**Application by Mallard Pass Solar Farm Limited for an Order
Granting Development Consent for the Mallard Pass Solar Project
– project ref. EN010127**

Submission by Mallard Pass Action Group (MPAG)
– unique ID ref. 20036230

**Deadline 3:
Comments on Responses to ExA's First
Written Questions**

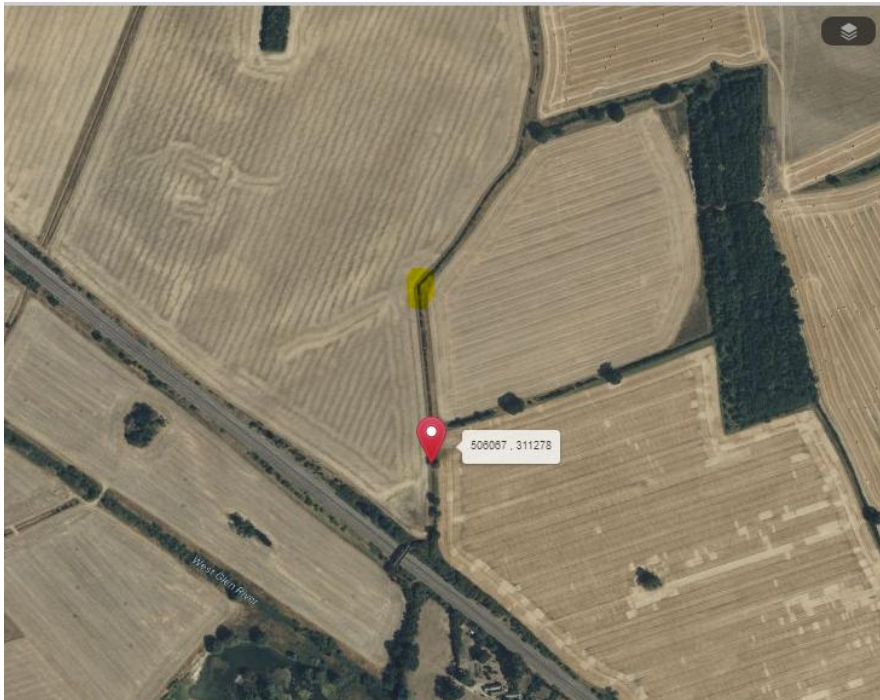
Unfortunately this new photomontage is still too close to VP6B. If it were slightly further North on the corner of BrAW/1/1 as highlighted on the map, it would show you the full extent of the view all the way to Carlby, you can even see the church in the distance. All the fields that can be seen from the revised suggested VP are highlighted in yellow. The original VP6B was taken in a completely inappropriate location at a lower level by the side of the railway line.

This particular view demonstrates why it is important to walk the PROWs in both directions, looking North the view is expansive.
